ULNRC-04743

**DOCKET NUMBER 50-483
UNION ELECTRIC COMPANY
CALLAWAY PLANT
REVISION TO SG WATER LEVEL LOW-LOW
LCO APPLICABILITY AND ALLOWABLE VALUES IN
TECHNICAL SPECIFICATIONS 3.3.1 AND 3.3.2**

AmerenUE herewith transmits an application for amendment to Facility Operating License No. NPF-30 for the Callaway Plant.

CALLAWAY MODEL F STEAM GENERATOR
Figure B.1

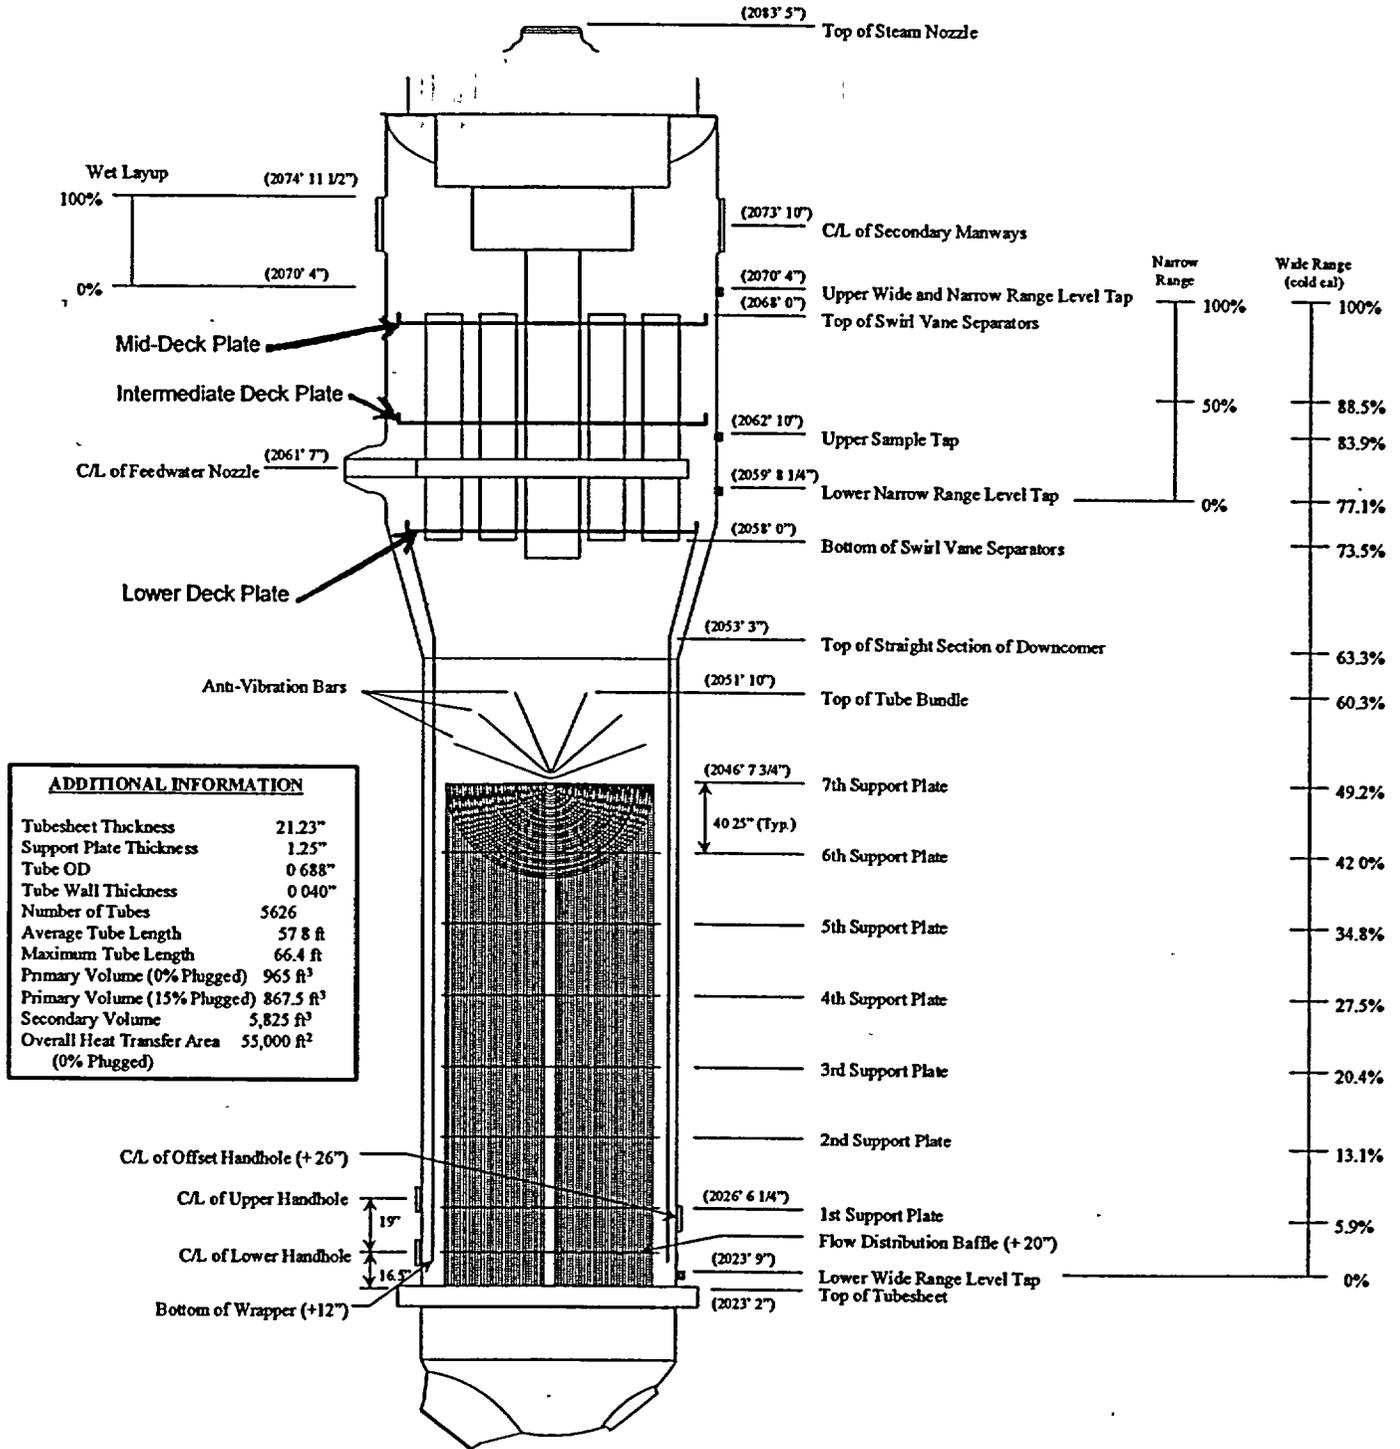
Attachment 6 is a schematic of the Callaway Model F steam generators. No other commitments are contained in this amendment application.

The mid-deck plate is located between the upper and lower taps used for steam generator water level measurements. This pressure drop impacts the low level setpoints for steam generators when the lower narrow range level tap is above the lower deck plate. A schematic diagram of the Callaway Model F steam generators is included as Attachment 6. This error source has not been accounted for and adversely affects steam generator low level setpoint uncertainty calculations as an algebraic bias that must be accounted for in the high direction.
